VT-24086-01
12-6-23

Project: Proposed Replacement Water Tanks
Meiners Oaks County Water District
Meiners Oaks Area of Ventura County, California
Subject: Addendum to Geotechnical Engineering Report
Reference: Geotechnical Engineering Report, Two Proposed Water Tanks, Meiners Oaks Water District, Meiners Oaks area of Ventura County, California. File VT-24086-01, Report 09-2-6, February 6, 2009, Earth Systems Southern California

| SITE PLAN | |

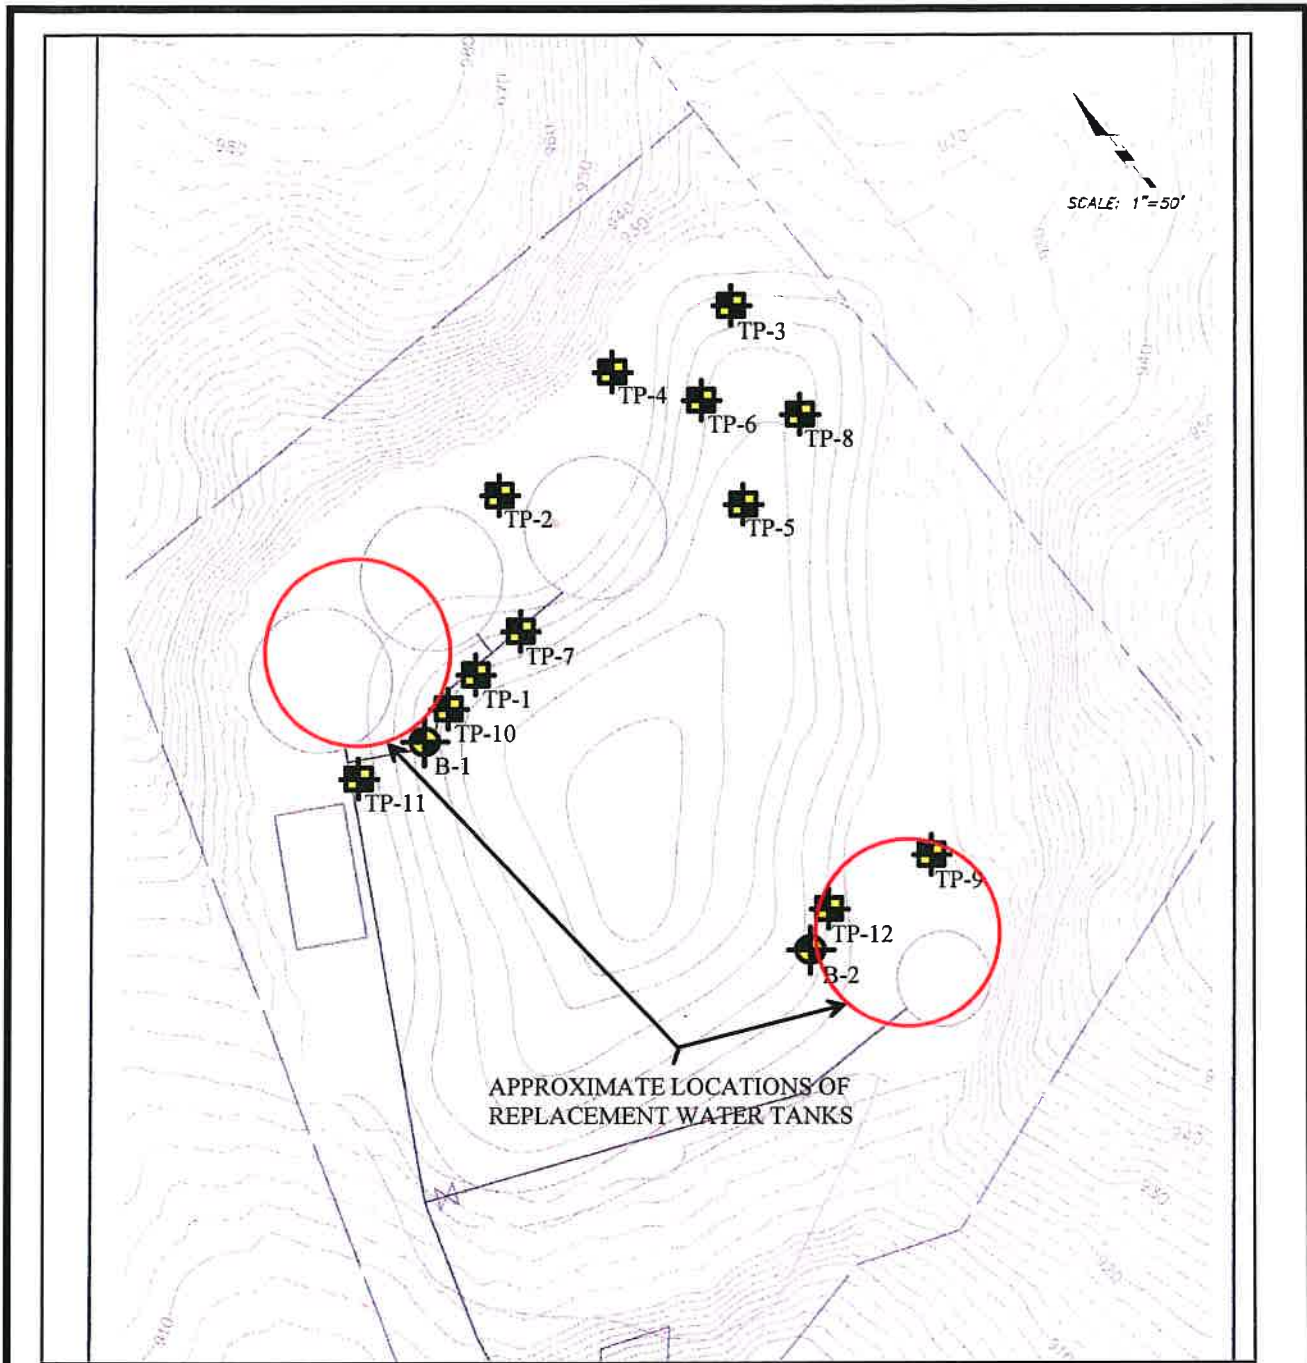
On May 2, 2012, four additional test pits were excavated near the proposed limits of the new tank diameters (see attached Site Plan). Bedrock was encountered in two of the test pits, but fill soils were not penetrated in two of the test pits because of a shallow water table. On May 30, 2012, two borings were drilled near the proposed limits of the new tank diameters. These borings penetrated the fill soils and encountered bedrock. The maximum depth explored within the test pits and borings was about 25.5 feet below the existing grade. The test pits were excavated with a subcontracted backhoe. The borings were drilled using a solid stem 8-inch, diameter, hollow stem auger powered by a CME-75 truck mounted drilling rig.

It is our understanding that two to three of the existing water tanks may be replaced by two new water tanks because of performance and capacity issues. Since the preparation of the referenced Geotechnical Engineering Report, the past topographic map representing the open reservoir has been overlain with the current topography and tank/building locations. This overlay map indicates approximately 30 feet of uncertified fill at the center of the reservoir and areas of the uncertified fill under the portions of the existing tanks. This is consistent with the results of the previous (ESSC 2009) and current field explorations.

The referenced Geotechnical Engineering Report provided five methods for mitigating the potential settlement below the proposed water tanks. It is our understanding that the Client's preferred method is utilizing rammed aggregate piers (RAP's). As previously discussed in the referenced report, the contractor should determine the RAP's construction feasibility and design. This design should include depth, spacing, and diameter of the RAP's. At a minimum the RAP's

should be overlain by an approximately 5-foot mat of engineered fill to provide a uniform support for the tank base. Any dewatering for construction purposes should be performed cautiously to minimize the effect of reducing pore water pressure and buoyancy forces which could lead to additional settlement below the existing tanks for which removal is not planned.

2010 California Building Code (CBC) (ASCE 7-05) Seismic Design Parameters

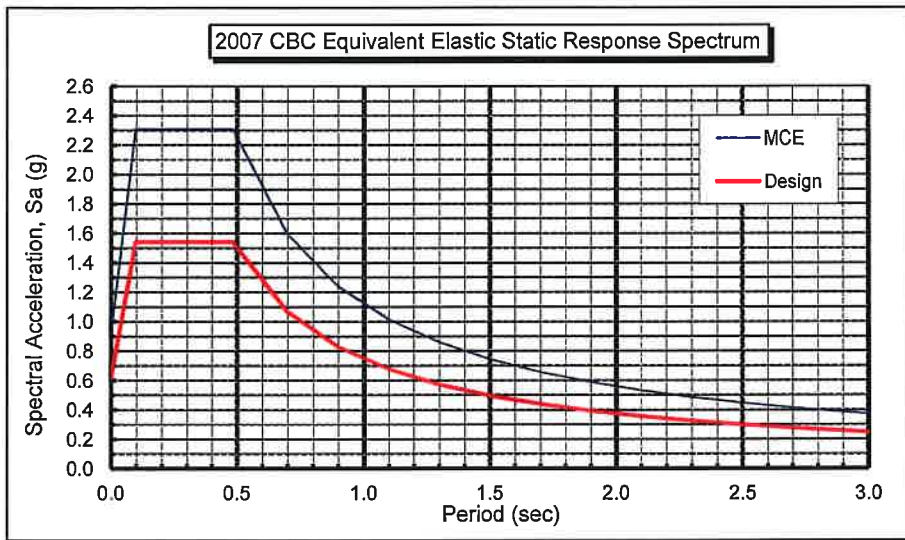
This site, like all other sites in the general area, can be affected by moderate to major earthquakes centered on faults in southern California. An estimate of the seismic shaking that the proposed development could experience was made by a calculation (dividing the S_{DS} seismic design value by 2.5) as recommended in the 2010 California Building Code. This calculation results in an estimated peak horizontal ground acceleration of about 0.62-g.

The latest adopted version of the California Building Code (2010) specifies that peak ground acceleration for design purposes can be determined either from a site-specific study taking into account soil amplification effects or from results of regional probabilistic analyses of spectral accelerations with adjustments made based on subject site soil profile. The second option has been chosen for this study. The United States Geological Survey (USGS) has undertaken a probabilistic earthquake analysis that covers the continental United States. Determined spectral acceleration values can be adjusted for five common soil/rock classes. The site geographic coordinates (34.4624° north latitude and 119.2771° west longitude) were input into the USGS's web based Seismic Hazard Curves and Uniform Response Spectra calculator to determine the site's short term (0.2 sec.) and long term (1.0 sec.) spectral accelerations. Spectral acceleration parameters that are applicable to seismic design as well as a list of nearby faults are attached to this letter.
